INTERNATIONAL STANDARD ISO 1101:2012
TECHNICAL CORRIGENDUM 1

Geometrical product specifications (GPS) — Geometrical tolerancing — Tolerances of form, orientation, location and run-out

TECHNICAL CORRIGENDUM 1

Page 26, 12.2, Figure 53 a)

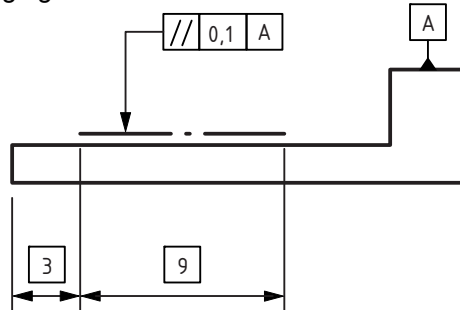
Replace the figure with the following figure:
